ADDENDUM NO. 1

EL PASO WATER

NORTHEAST FRANKLIN DISTRIBUTION WATER MAIN SEAN HAGGERTY PAHSE I

BID NO. 23-22

Exhibit A – Tie-in location

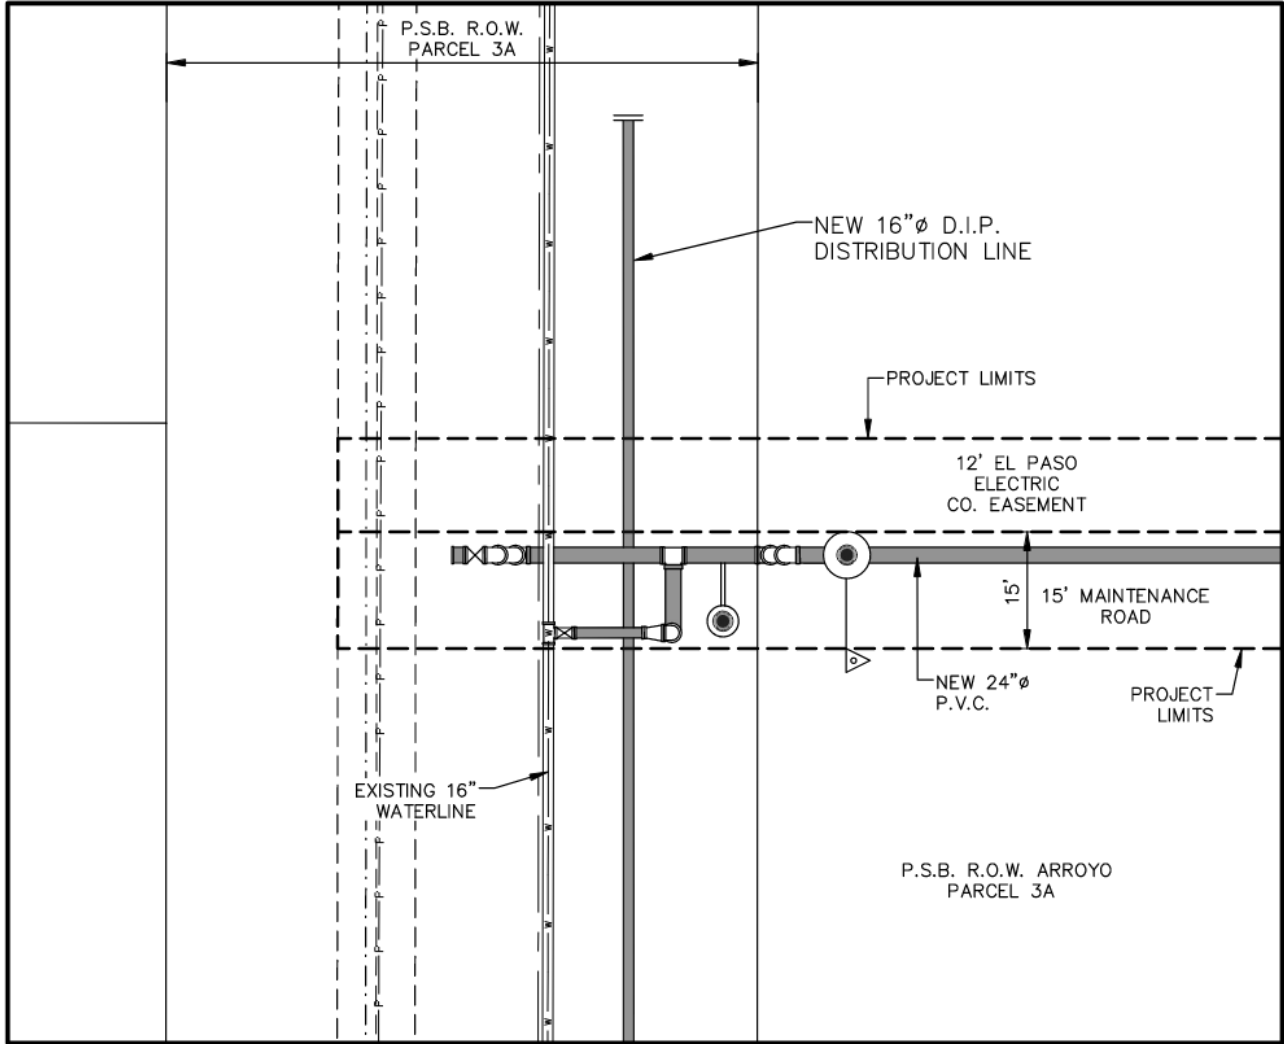
- A. When is the Arroyo/Channel work expected to start or be completed?

The EPW Enhanced Arroyo project is a multi-phased construction project. NE ASR Phase 1 project limits (which is currently being advertised) do not extend to the NORTHEAST FRANKLIN DISTRIBUTION WATER MAIN SEAN HAGGERTY PHASE I & NORTHEAST FRANKLIN INTERCEPTOR SEAN HAGGERTY PHASE project limits with exception of a watermain connection that is shown in the attached Exhibit A. Successfully bidder will be required to coordinate work as relates to sequencing of this work. Future NE ASR phases to include grading and arroyo improvements are not anticipated to start construction until after the NORTHEAST FRANKLIN DISTRIBUTION WATER MAIN SEAN HAGGERTY PHASE I & NORTHEAST FRANKLIN INTERCEPTOR SEAN HAGGERTY PHASE
